# Modification Recommended Service Note

Supersedes:  
N4692D-02

## N4692D Electronic Calibration Module (ECal)

Serial Numbers: MY57450000- MY59410001

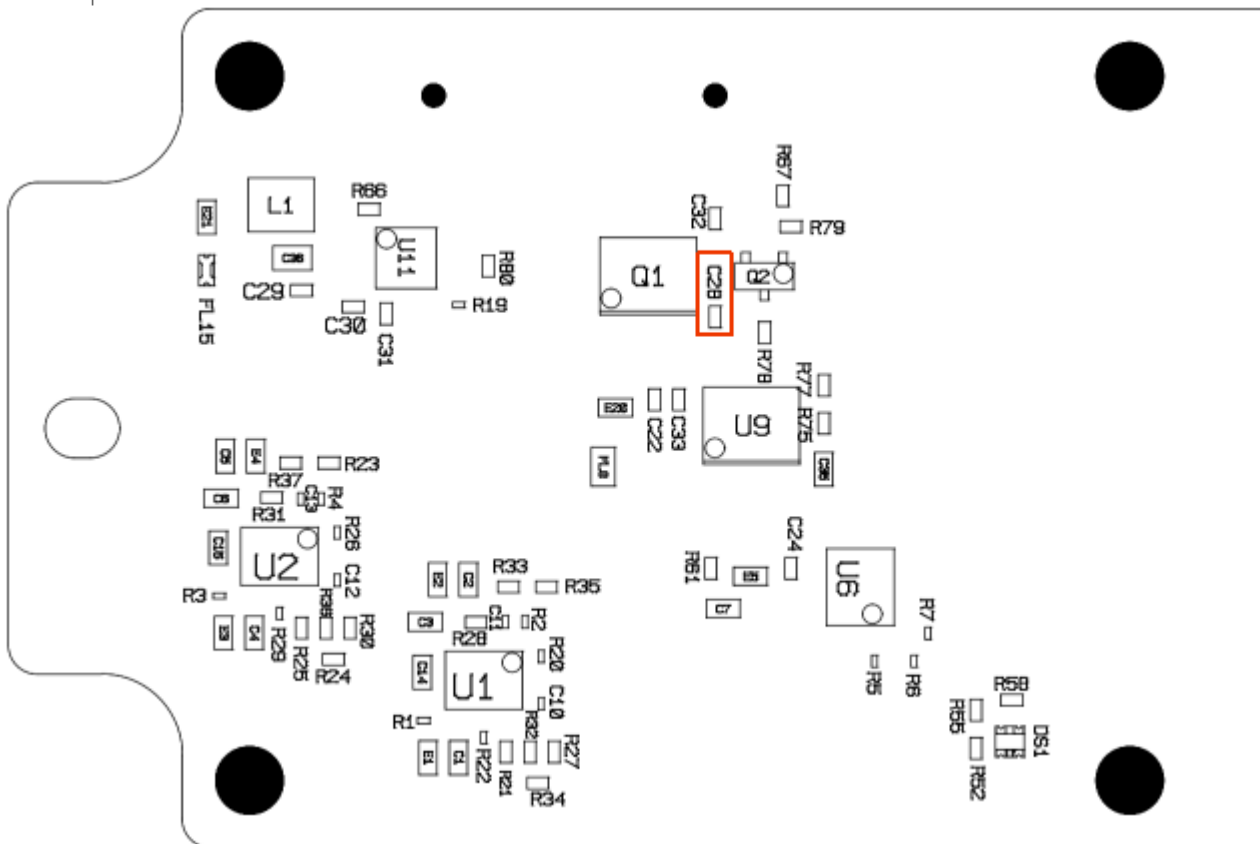
The heater circuit in the N469xD ECal modules was initially designed with a dampening capacitor. It was found in a small number of ECal modules that a resonance can develop in this circuit after the modules is warmed up. This resonance can cause an RF tone between 140 MHz and 150 MHz to be injected onto the signal path.

The dampening capacitor was eliminated in all ECal modules with serial prefix MY5941 and above.

Open the ECal module and remove the N4690-63004 printed circuit board. On this board, locate the C28 capacitor indicated here:

If this capacitor has been removed, no further action is required. Reassemble the ECal module.

If this capacitor exists on this board, this capacitor should be carefully unsoldered and removed, or the N4690-63004 printed circuit assembly should be replaced. Once this is done, reassemble the ECal module.
